APPLICATION UNDER HOBART INTERIM PLANNING SCHEME 2015

Type of Report: Committee
Council: 19 November 2018
Expiry Date: 26 November 2018
Application No: PLN-18-603
Address: 211 CHURCHILL AVENUE , SANDY BAY
Applicant: BEE NEWMAN
208A COLLINS STREET
Proposal: Partial Demolition and Two Multiple Dwellings (One Existing, One New)
Representations: Five (5)
Performance criteria: General Residential Zone Development Standards

Figure 5: The proposed site plan.

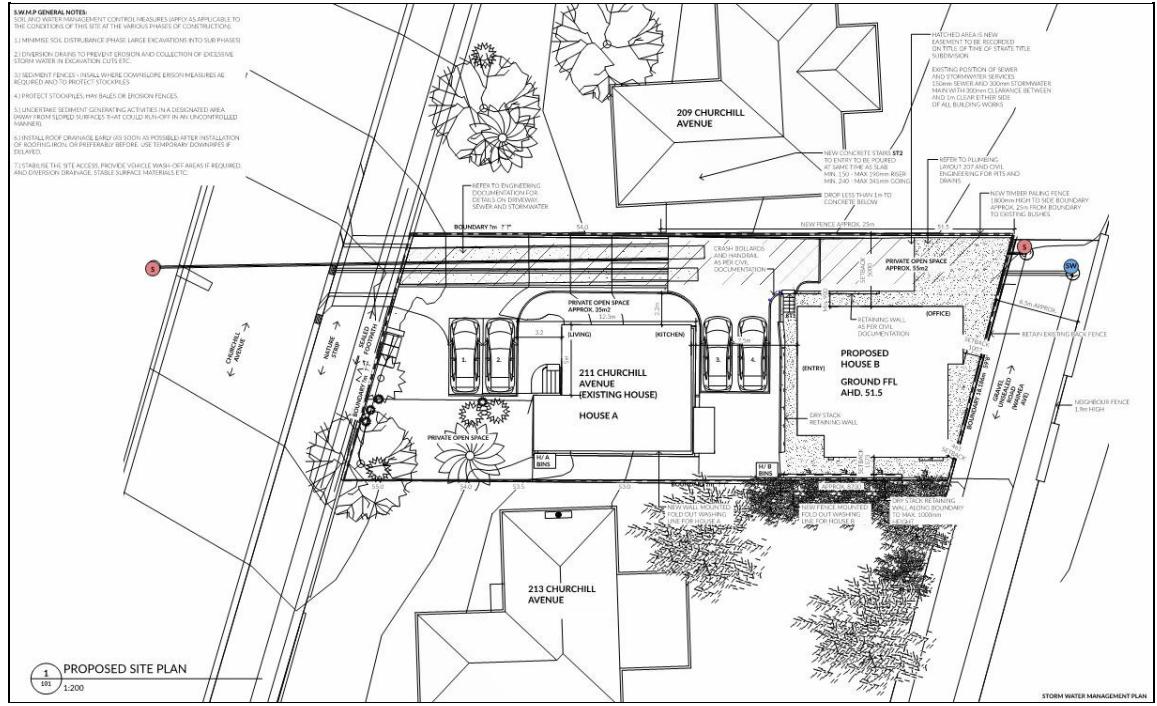
- 6.7.2 The proposal includes a frontage setback of 0.46m from Waimea Avenue.
- 6.7.3 The proposal does not comply with the acceptable solution; therefore assessment against the performance criterion is relied on.
- 6.7.4 The performance criterion at clause 10.4.2 P1 provides as follows:

- 6.7.5 The proposed building frontage is not parallel with the Waimea Avenue laneway and therefore setback distances range from a minimum of 0.46m to a maximum of 1.5m. Including the subject site, there are seven properties that have frontage to the Waimea Avenue Laneway. Those properties and their setbacks from the laneway are as follows, noting that a dwelling is defined to include 'outbuildings and works normally associated with a dwelling':
- 47 Waimea Avenue: No setback.
 - 215 Churchill Avenue: 17m approximately.
 - 213 Churchill Avenue: 19m approximately.
 - 209 Churchill Avenue: No setback.
 - 45 Waimea Avenue: No setback.
 - 45A Waimea Avenue: No setback.

It is evident from the above that no setback to the laneway is the prevailing setback. The proposed setback, which varies from just under half a metre to 1.5m is considered to be compatible with the existing dwellings in the street.

- 6.8.2 The proposal includes a frontage setback of 0.46m from Waimea Avenue.
- 6.8.3 The proposal does not comply with the acceptable solution; therefore assessment against the performance criterion is relied on.
- 6.8.4 The performance criterion at clause 10.4.2 P3 provides as follows:

The proposed dwelling reaches a maximum building height of 8.35m above natural ground level. When viewed from adjoining dwellings, the apparent bulk of the proposed dwelling is minimised through a combination of the siting, materials and setback.

The siting of the proposed dwelling is lower in elevation than the dwellings on adjoining lots. Combined with some minor excavation, the apparent bulk of the building has been reduced so that the roof of the proposed dwelling appears approximately 1m in height taller than the existing dwelling on the site.

The building materials have also been chosen to lessen the apparent height and massing. While the ground floor uses a darker brick to connect the structure with the earth, the upper floors use a lighter brick to give the impression of a two storey building.

The building has been designed to transition in height and setback. When viewed from the adjoining dwelling at 213 Churchill Avenue, the ground floor side boundary setback of 1.57m transitions to a setback of 3.2m on the first floor and 5.1m on the second floor. This transition serves to minimise the visual impact of the proposed dwelling by reducing the apparent scale, bulk and proportions. When viewed from 209 Churchill Avenue, there is a 5m side boundary setback and increased frontage setback on the second floor to reduce the apparent scale.

4. Show dimensions, levels, gradients and transitions, and other details as Council deem necessary to satisfy the above requirement.
5. Show the proposed vehicle turning area in front of House B (as shown on site plan, dwg 101, dated 30/8/18) having a larger radius turn, similar to those in front of House A. This will require an amendment to the design of the retaining wall and stairs at the southwest corner of House B.
6. Include certification from a suitably qualified engineer that the layout of the driveway, parking and turning areas will allow B85 vehicles to get in/out of the parking spaces with no more than a 3-point turn.

Figure 12: The approved site plan for the approved extension at 213 Churchill Avenue. The green depicts the second floor extension to the house, with the blue being a new deck. The existing dwelling on the subject site is partially outlined in orange.

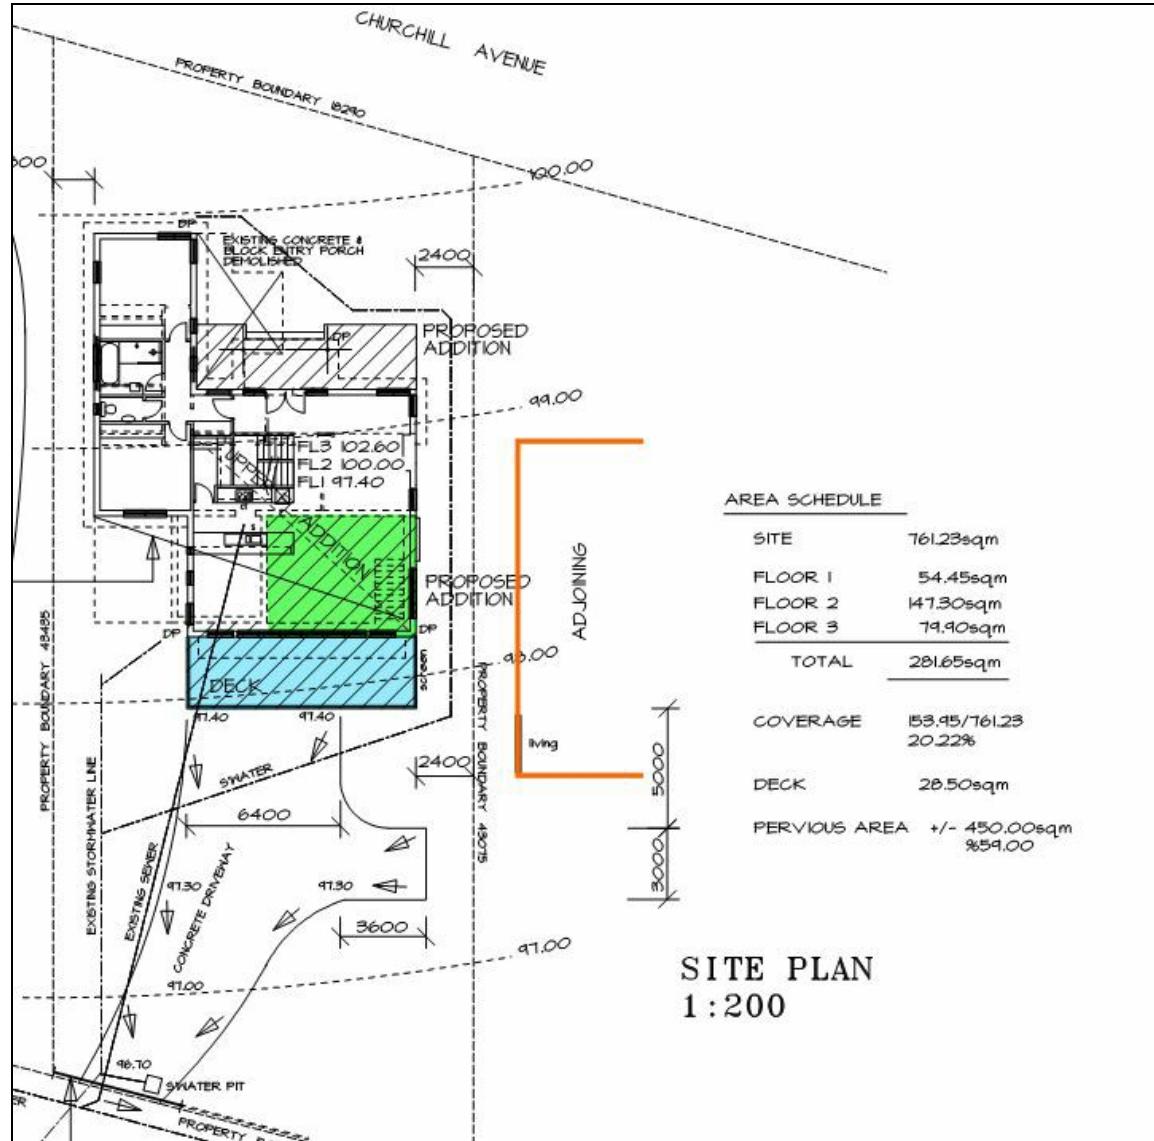
- The neighbour at 213 Churchill Avenue has a planning approval for a rear extension (PLN-17-249), refer to image below. It has no building or plumbing approval. The permit will lapse on 7 June 2019 if not substantially commenced prior to that date, or an extension of time is sought and approved. However, it is noted that the extension does not extend beyond the rear elevation of the existing house on the subject site, and therefore the proposed shadow diagrams demonstrate that it would not be impacted by overshadowing until at least 12pm midday on June 21 (midwinter). As such, it would receive three hours of unimpacted light between 9am and 12 midday in the middle of winter. It is also noted that the approved extension would result in the house being three storeys.
